LFS/479

APPLICATION FOR PERMISSION  
UNDER SECTION 16 OF  
THE TOWN PLANNING ORDINANCE  
(CAP.131)

**Proposed Temporary Open Storage of Scrap Metal for a Period of 3 Years  
at**

**Lots 1973 (Part), 2028 RP (Part), 2029, 2030 (Part), 2031 (Part), 2032 RP  
(Part), 2033 RP (Part) in D.D. 129 & Adjoining Government Land, Deep  
Bay Road, Lau Fau Shan, Yuen Long, N.T.**

Figure 4

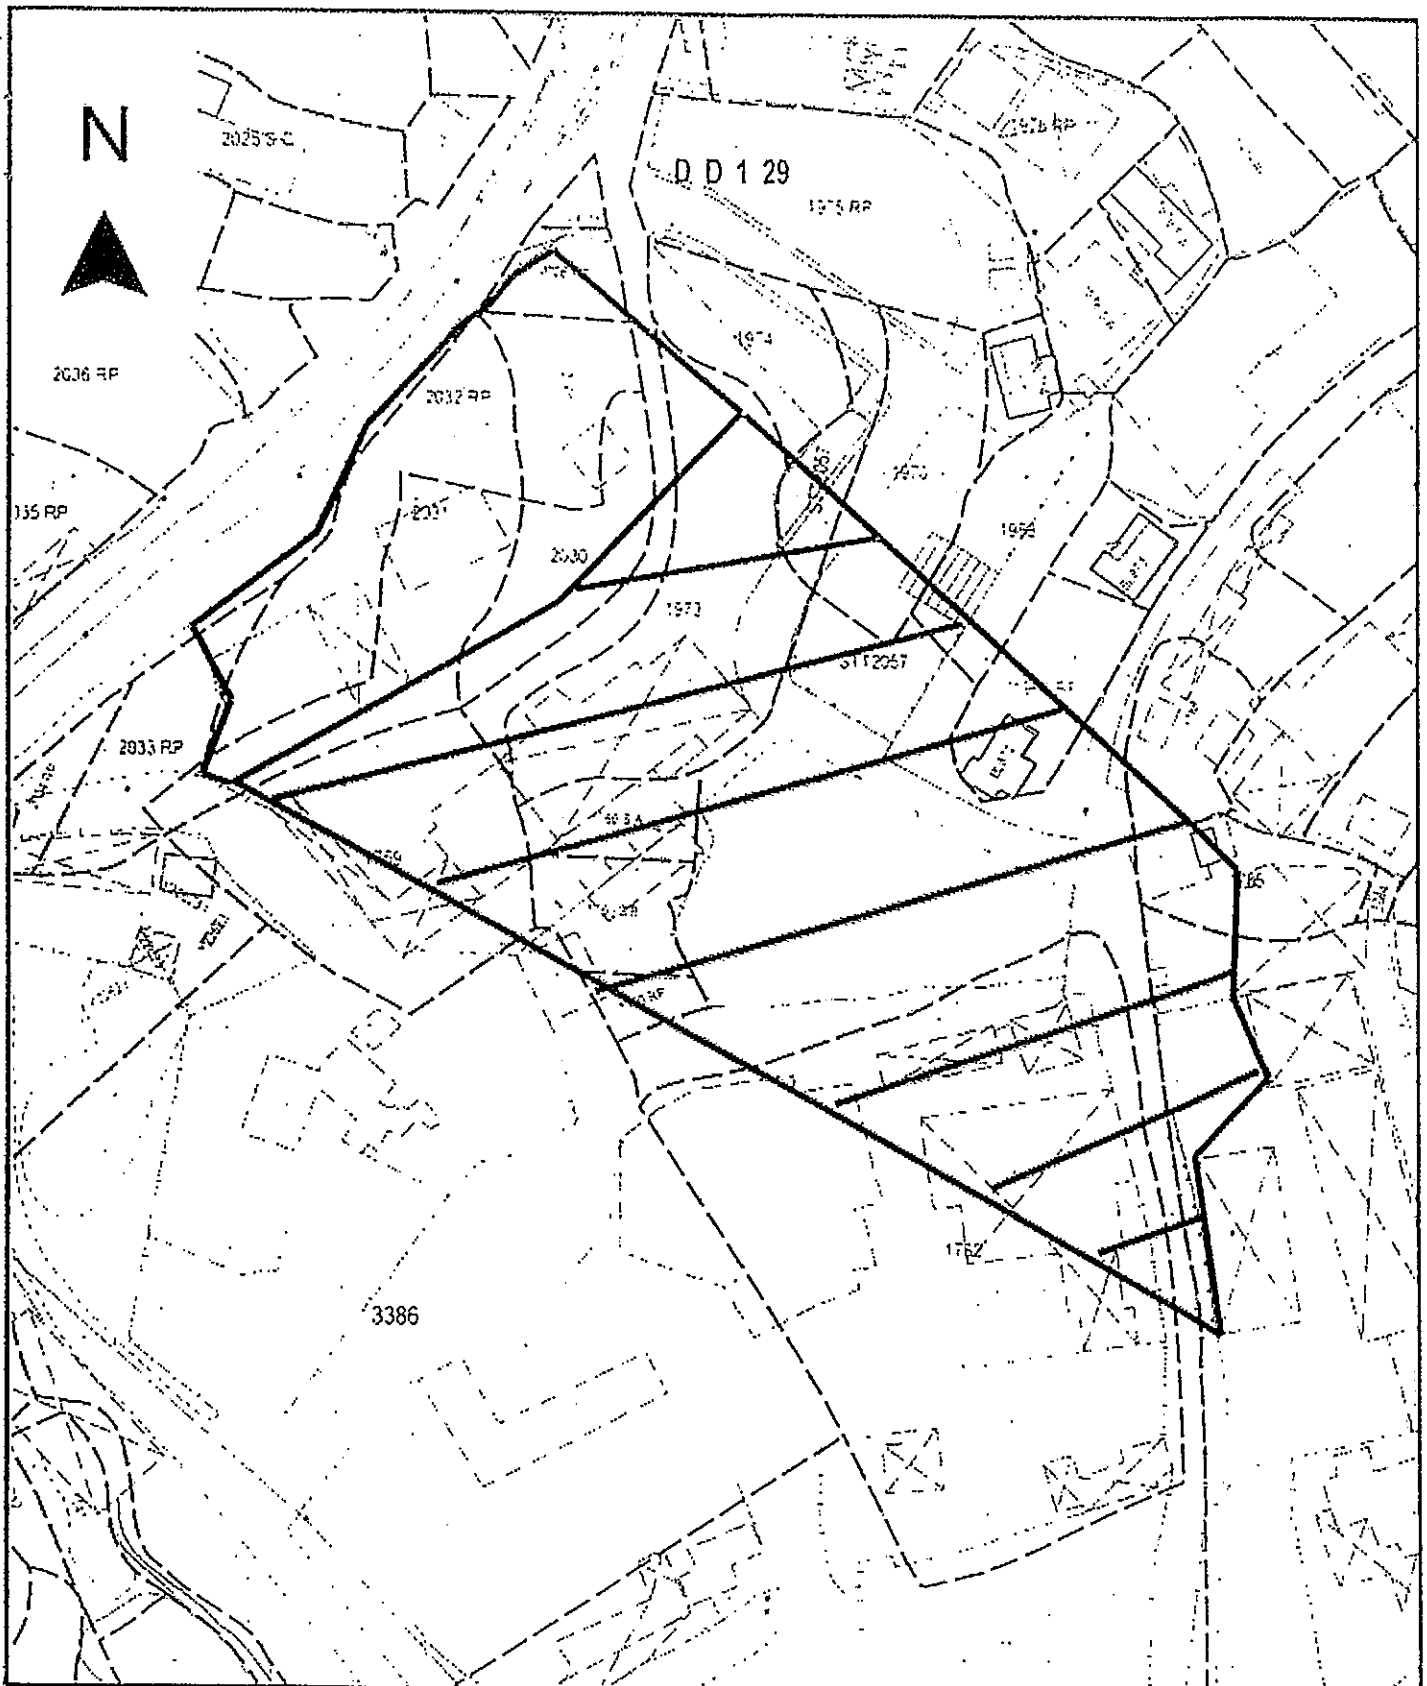
- (i) the existing drainage facilities that the applicant planned to discharge to is not under DSD's purview. Furthermore, the proposed underground pipe may run into private Lots. The applicant should consult DLO/YL of LandsD and seek consent from the relevant owners for any drainage works to be carried out outside his lot boundary before commencement of the drainage works;

- (ii) further to (i) above, since there is no record of the said discharge path, please provide site photos to demonstrate its presence and existing condition of the existing watercourse as well as the downstream of the watercourse. Please also provide details for the outfall connection of the underground pipe to the existing watercourse;

- (v) the cover levels and invert levels of the proposed U-channels, catchpits/sand traps should be shown on the drainage plan;
  - (vi) the acute flow path at catchpit located at the southeast side of the side is not desirable. Please reconsider the alignment of the proposed U-channel and the location of the concerned catchpit; and

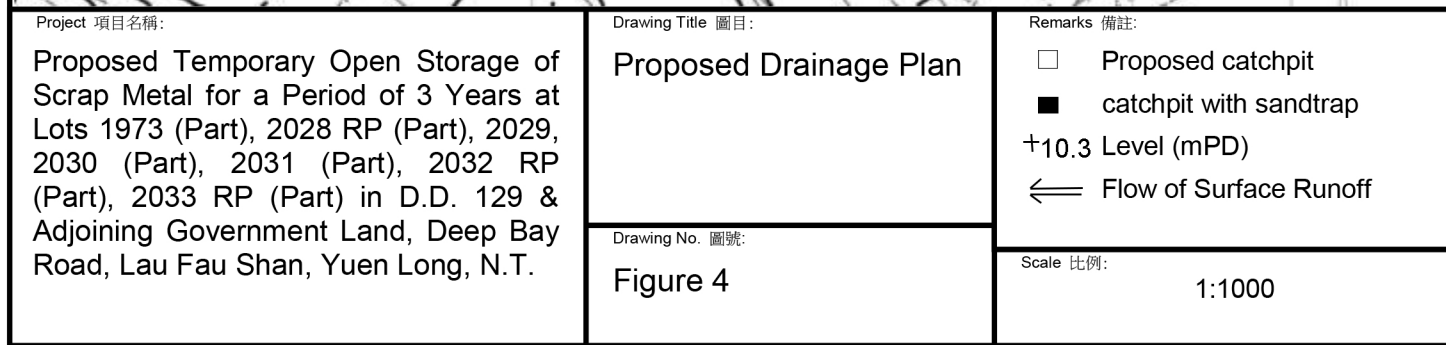
Antiquities and Monuments Office of the Development Bureau's comments	Applicant's response
Please confirm / clarify if there is any ground excavation proposed for the temporary open storage of scrap metal, including but not limited to site formation works, building works, drainage works, etc. If affirmative, the applicant is required to provide details of the proposed works, e.g. the location, extent and depth of the proposed ground excavation and so on for the assessment of the Antiquities and Monuments Office on the impact on the Site of Archaeological Interest and for consideration on the appropriate mitigation measures at the early planning stage if ground excavation works is required with strong justifications.	Noted. There will be no site formation works or building works except the excavation of land for the provision of surface U-channel to be stipulated by CE/MN, DSD as one of the approval conditions of the planning permission. According to the submitted drainage proposal, the proposed surface U-channel will be provided along the proposed site boundary and it will be 675mm deep and wide in order to intercept the stormwater generated at the application site and its external catchment. The location of the proposed drainage works is shown in the attached Figure 4 for your information.
